Staff's Preliminary Calculations:
Indications that the Groundwater
Release Criterion may not be met within
the Proposed Remediation Time Frame

Former Cimarron Facility
Guthrie, Oklahoma

March 10, 2022

John Saxton, NRC Hydrogeologist

Staff's Initial Flow Model Results Extraction

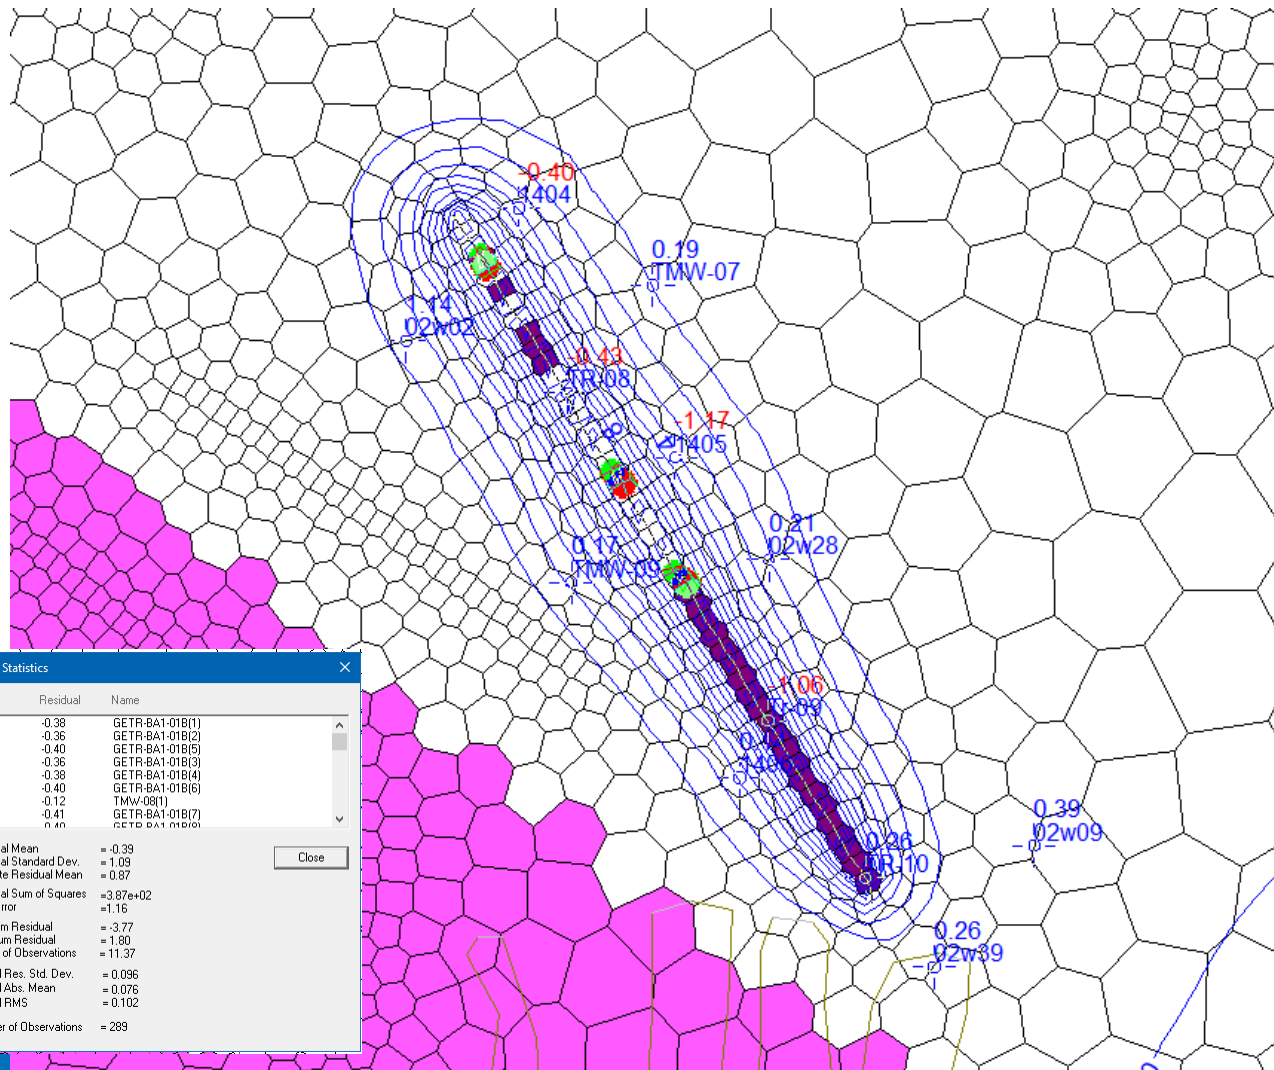
- Layer 1 Transition Zone
 - Magenta – Layer 1 pinch out (bedrock)
 - Trench located in linear array of small rectangular cells
 - Trench extends to Layer 6 (Mudstone B)
 - Purple – cell in Layer 1 is dry
 - Number above well label is residual (observed drawdown minus model-predicted drawdown)
 - Residual statistics in lower left hand corner
-
- Drawdown at the end of the pumping test at GETR-BA1-01
 - The Transition Zone was assigned a hydraulic conductivity of 0.4 feet per day

Model Prediction

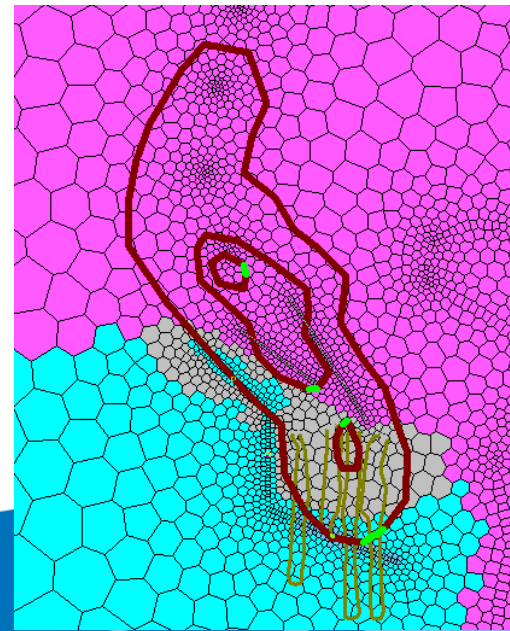
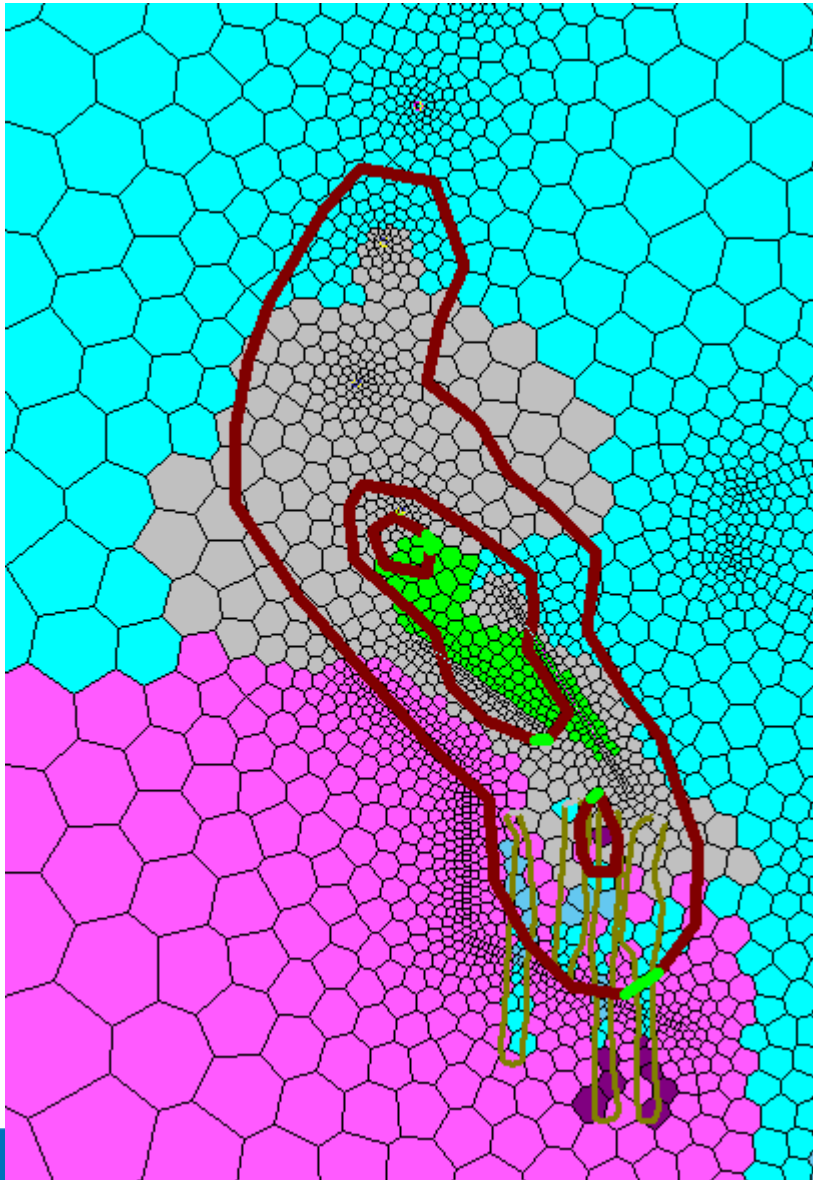
- After 150 months, the green contour indicates release criterion not achieved

Model Isotherms and Equivalent Distribution Coefficients

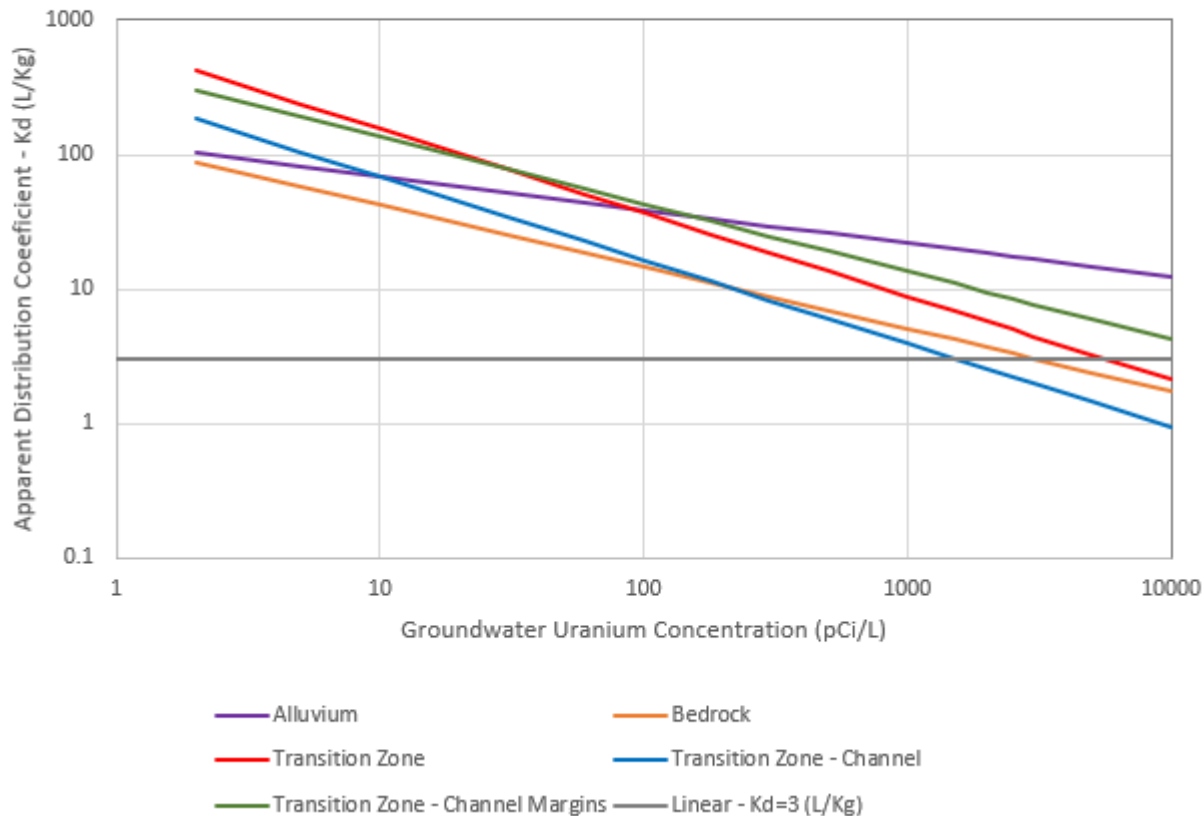
- The equivalent distribution coefficient (Kd) for the Transition Zone at a groundwater uranium concentration of 180 pCi/L is 25.6 L/Kg
- A Kd of 3 L/Kg was used by the licensee to predict remediation timeframes
- The Kd for the Alluvium is high because of the low concentration assigned to the source for this simulation
